UNITED STATES ENVIRONMENTAL PROTECTION AGENCY

January 6, 2023

RE: Southern Impoundment Remedial Action Updated Supporting Deliverables Following Remedial Contractor Selection
San Jacinto River Waste Pits Superfund Site
Unilateral Administrative Order CERCLA Docket No. 06-05-21

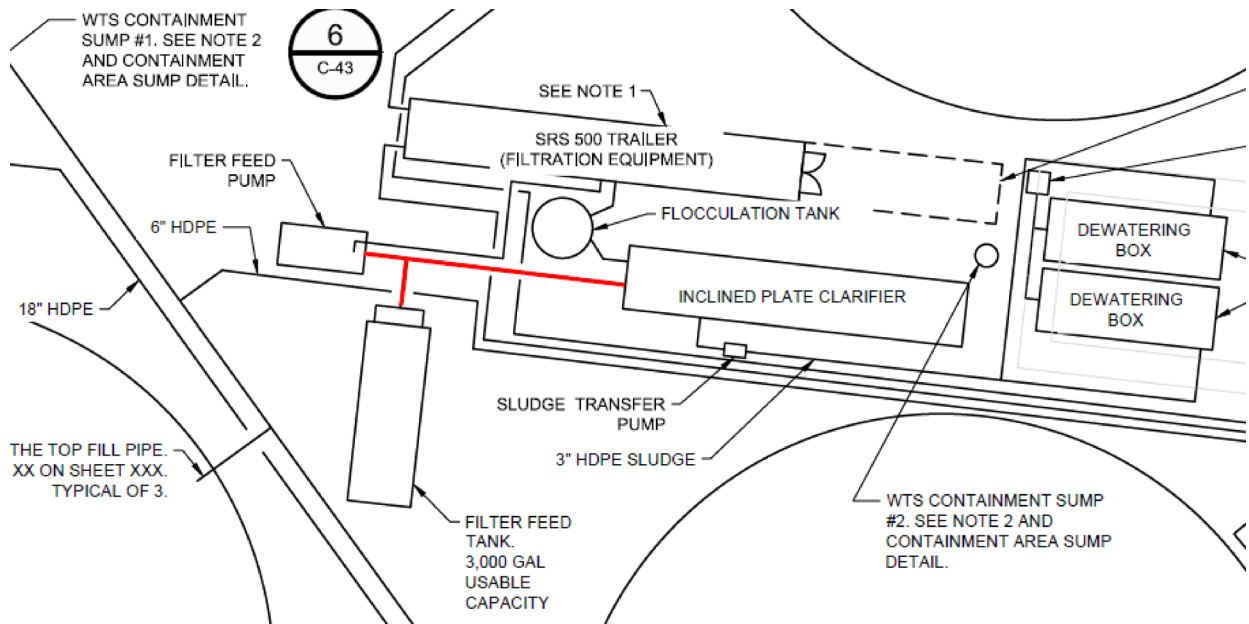
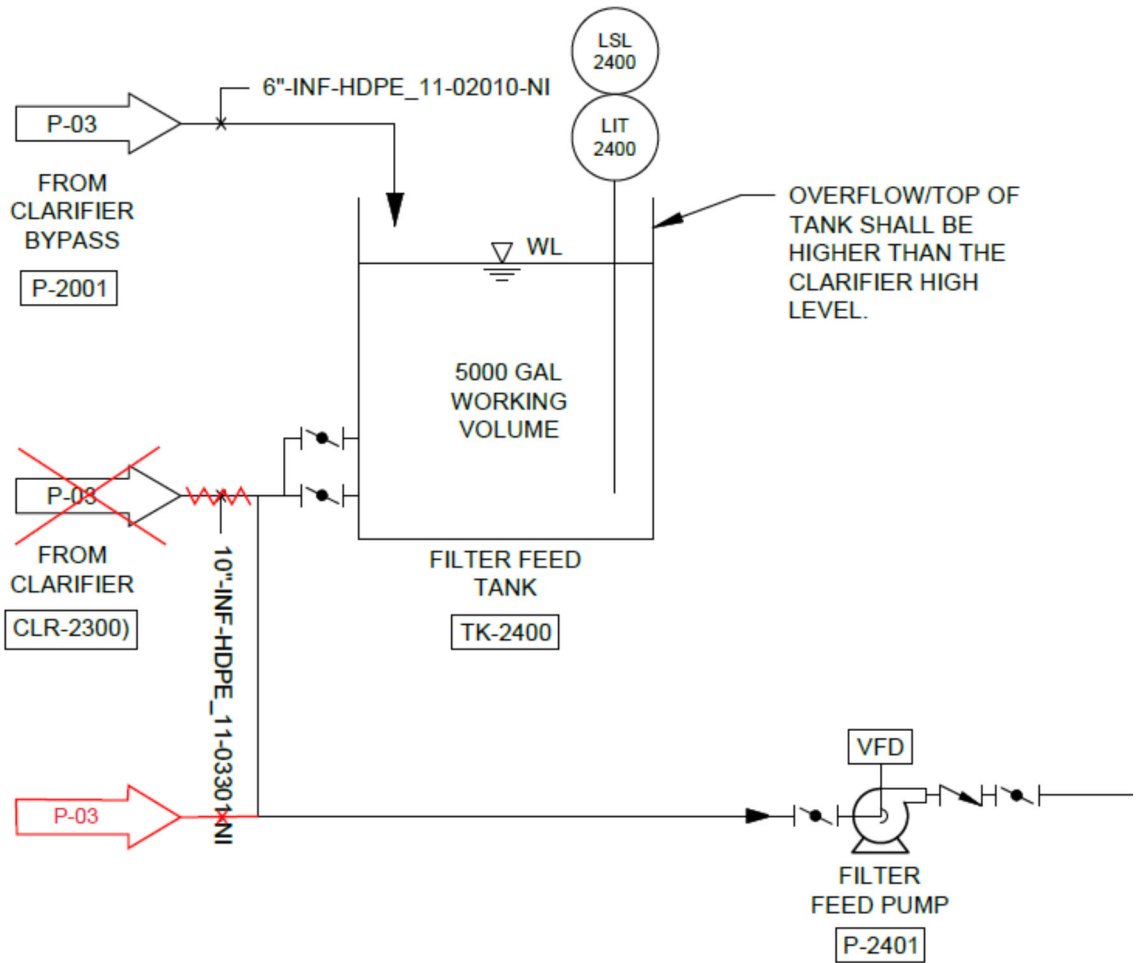
8. **Appendix A, Water Treatment System Design Drawings:** Replace the draft versions of P-02, P-03, P-04, and P-05 with the P.E. signed and sealed versions that were included in Appendix D of the Southern Impoundment Final 100% Remedial Design Addendum.
9. **Appendix A, Water Treatment System P&ID:** In the Water Treatment System P&ID, notes 1 and 2 state the P&IDs are conceptual, to be finalized by the contractor, and the treatment system design is preliminary and subject to change. Remove these statements as these plans and design should be considered final.
10. **Water Treatment System P&ID (3 OF 4):** With respect to the P-03 from the clarifier portion of the water treatment system, there does not appear to be a direct line from the filter feed tank to the filter feed pump. See the image below for reference, and include the updated two graphics below for clarification in the FSP.

Upon email conversation with GHD from December 19, 2022, EPA understands that the filter feed tank is included in the temporary water treatment system design to act as a buffer between the clarifier and the filter feed pump to modulate the flow to the filter feed pump. The filter feed tank will have two valves that allow bidirectional flow, allowing water to enter the tank from the clarifier and allowing water to exit the tank to send water to the filter feed pump. The design assumes a FRAC tank will be used which has limited connection sizes and two connections are needed for flow requirements. The filter feed tank will be off to the side of a direct line between the clarifier and the filter feed pump. The filter feed tank is included in the design for sequencing of operations, with high and low level sensors that will facilitate stopping and starting of the filter feed pump. Under normal operations, water would gravity flow from the clarifier to the filter feed pump, but there may be times when the flow rates don't match so water would be directed to the filter feed tank to modulate that flow.

The snipping below shows a modification to the process flow diagram from Drawing P-04 that more clearly shows how flow would go directly from the clarifier to the filter feed pump, with a line teed off to the filter feed tank, whereby water could be directed to the filter feed tank when the filter feed pump cannot keep up or is not operating. As the water rises within the filter feed tank, the sensor in the filter feed tank would communicate with the filter feed pump to turn back on. It should be noted that the system is gravity fed from the clarifier, hence the note pointing to the filter feed tank that the "overflow/top of tank shall be higher than the clarifier high level". The second snipping comes from Drawing P-08 and shows the direct line between the clarifier and the filter feed pump, with a line teed off to the filter feed tank off to the side. This clearly shows the direct line between the clarifier and filter feed pump.

Please include these updated graphics for clarification in the FSP.
